**CONTRACT DOCUMENTS
BOONE COUNTY, MISSOURI
BID NO: 25-24MAR05**

**ADDENDUM #1
(Issued March 21, 2005)**

BID FORM – Boatman Hill Storm Drainage Project - Project No. 9783

**TOEWALL & END SECTION
 (FOR R.C.P.)**

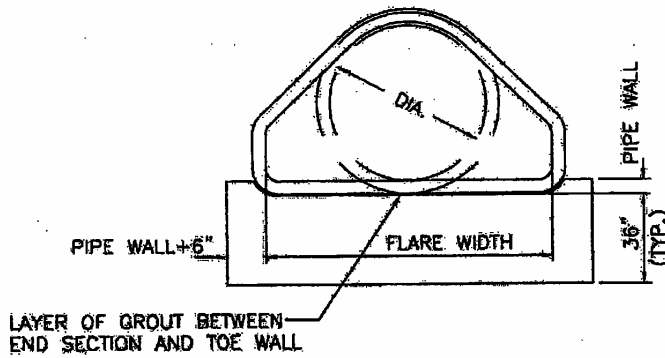
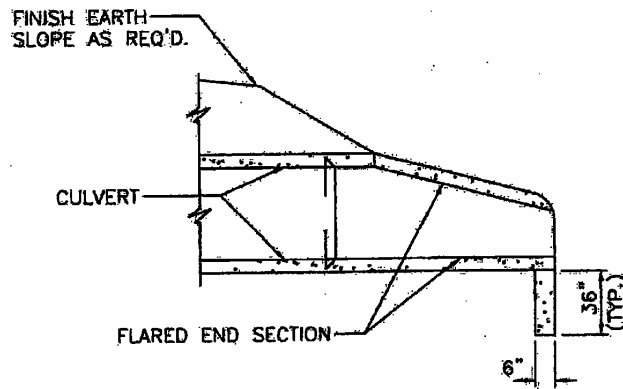
1. The 48" Flared End Section is to be placed on the up-stream end of the 48" RCP on the west side of Boatman Hill Road. Installation shall be according to the **attached** detail sheet and final grading will be adjusted accordingly to provide smooth contours around the flared end section. The plan sheets are not being revised to reflect this. (Note that the Toe Wall will be placed at the end of the flared end section as shown on the attached detail sheet in lieu of the Toe Wall shown on the plans for the upstream end of pipe (Detail ¹/_{C502}).
